# CITY OF ALBUQUERQUE

RE: **Francisco Lopez Residential  
Bridge/Eucariz SW  
Request for Pad Certification – Not Accepted**  
• **Lots 1-6**  
**Grading Plan Stamp Date: 9/25/12**  
**Certification Dated: 12/13/19**  
**Hydrology File: L11D067**

Dana Peterson  
Senior Engineer, Planning Dept.  
Development Review Services

## GRADING & DRAINAGE PLAN

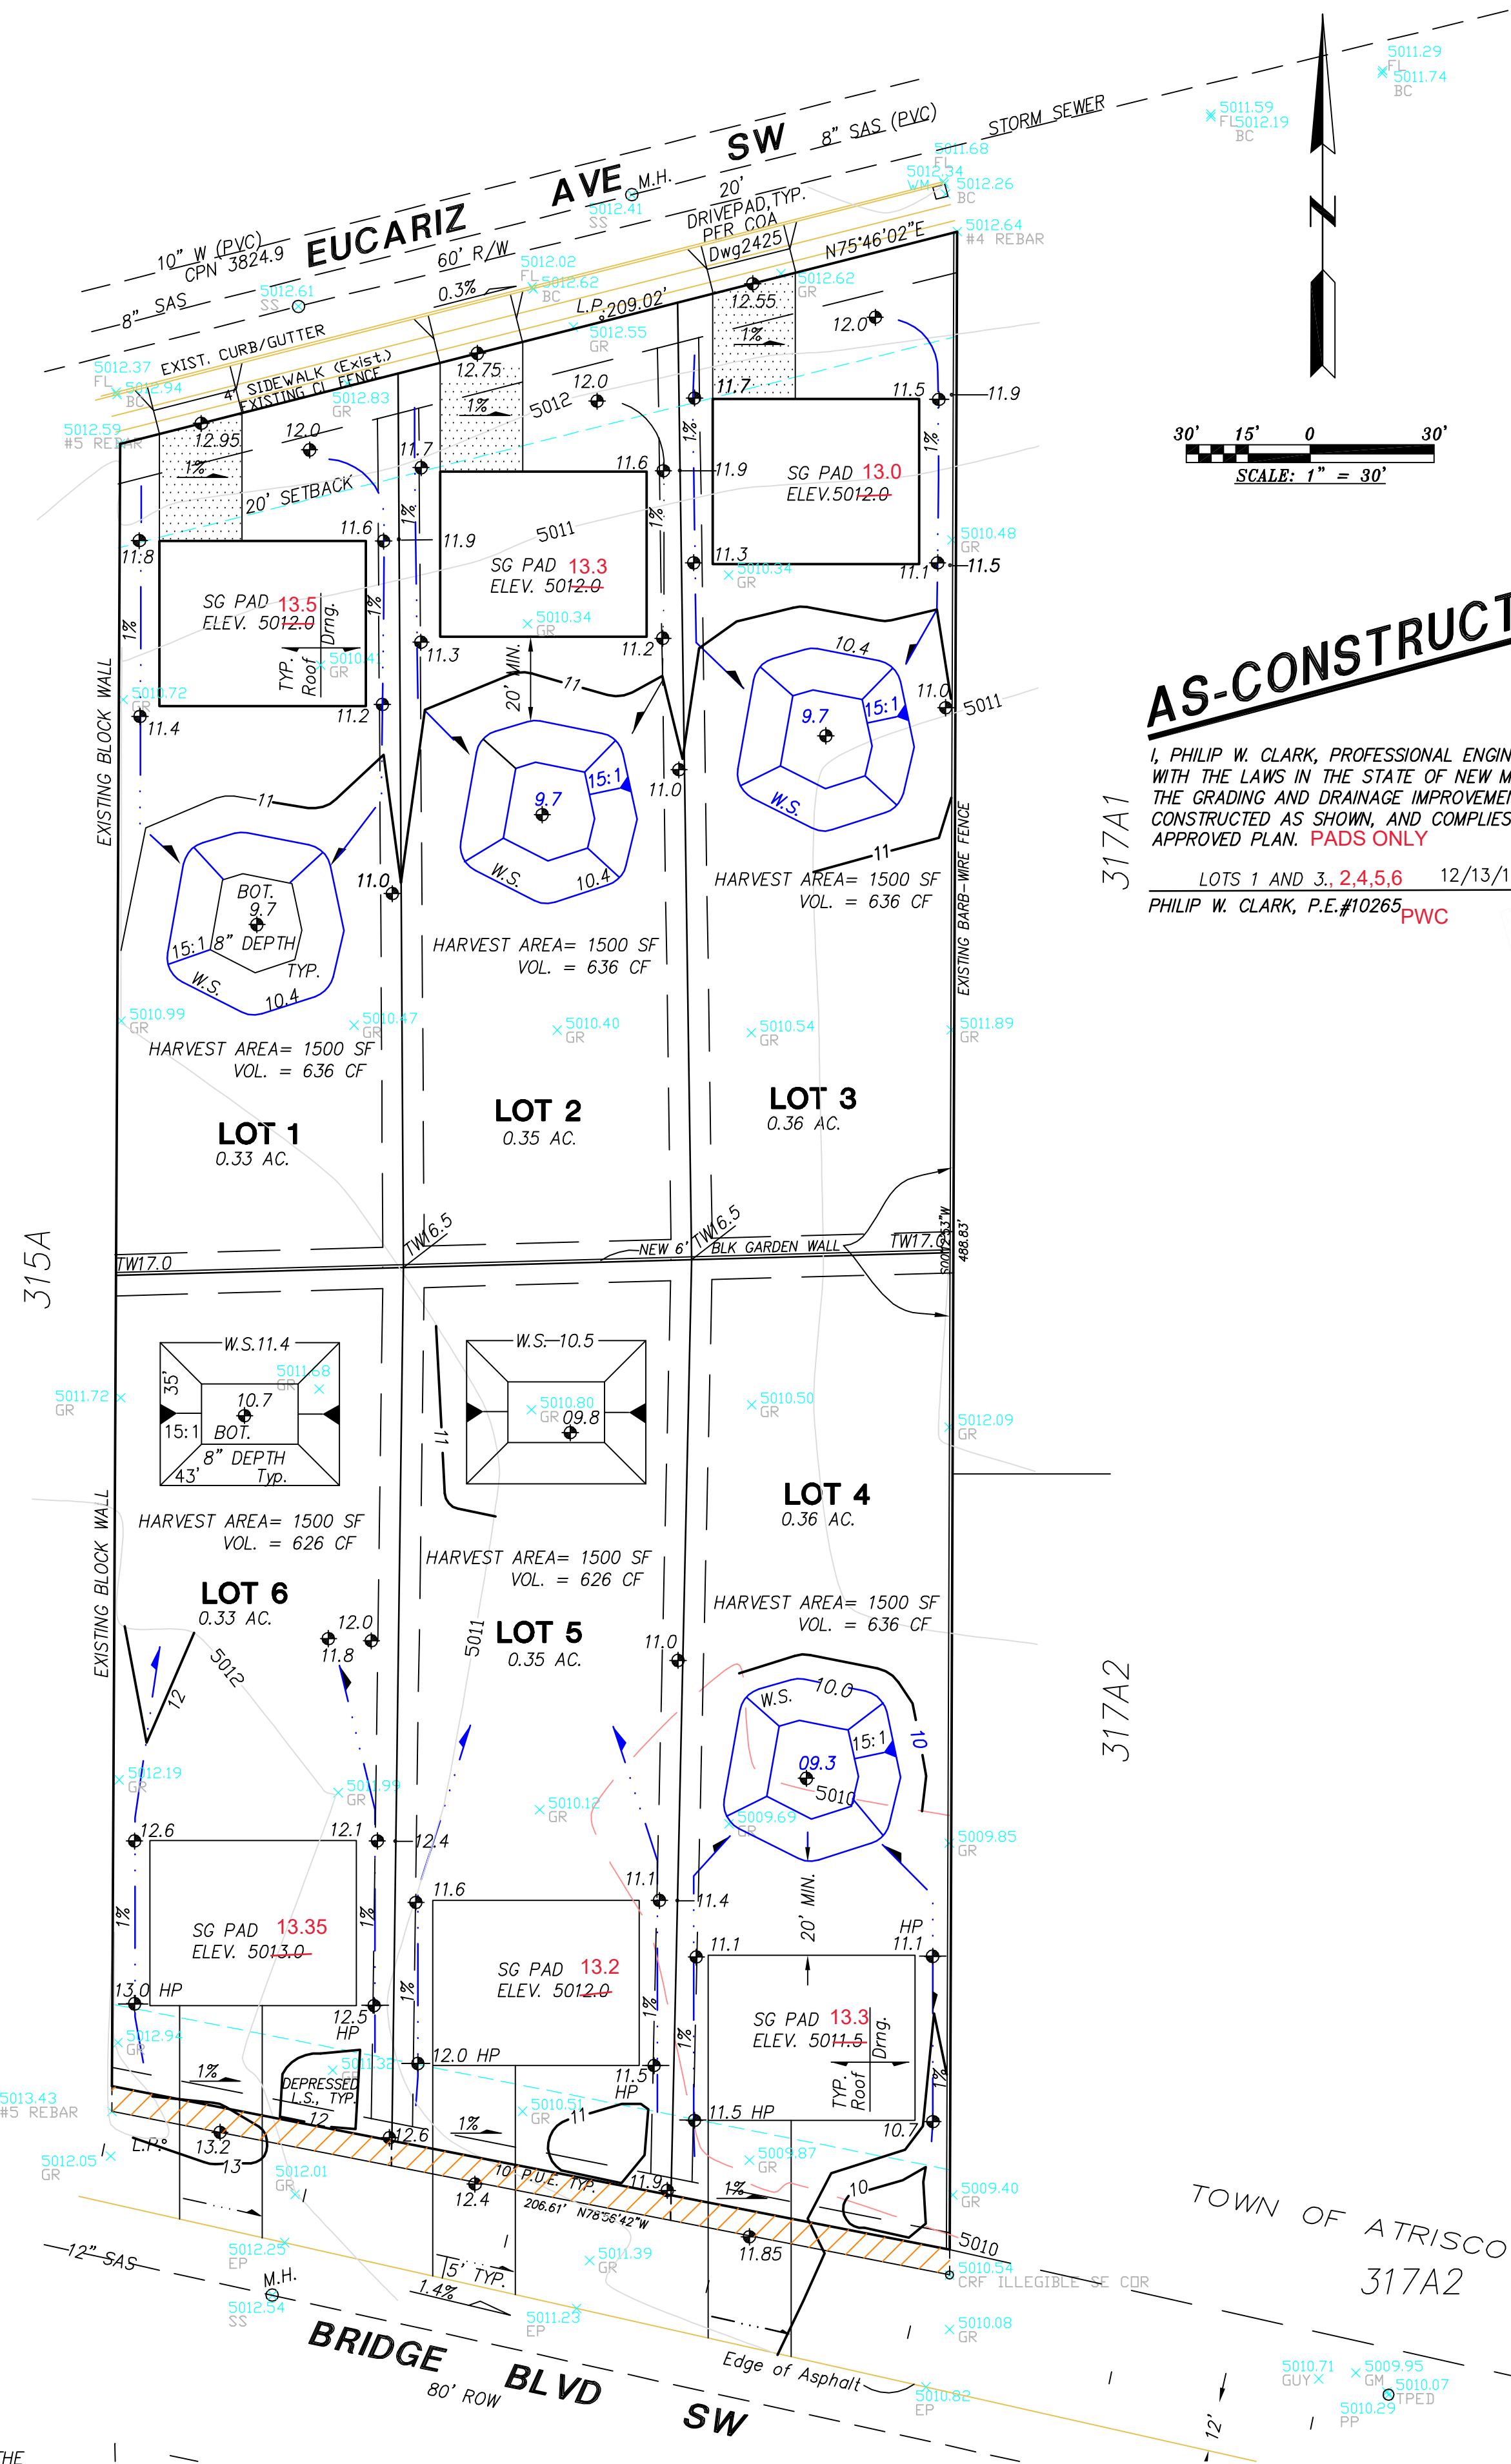
1. Use the Drainage Certification Language, per the DPM Chapter 22.7: *DRAINAGE CERTIFICATION WITH SURVEY WORK BY PROFESSIONAL SURVEYOR* or *DRAINAGE CERTIFICATION WITH VERIFICATION BY ENGINEER OF RECORD*; be sure to include surveyor information.
2. The ponds need to be constructed and surveyed, per the approved Grading Plan.
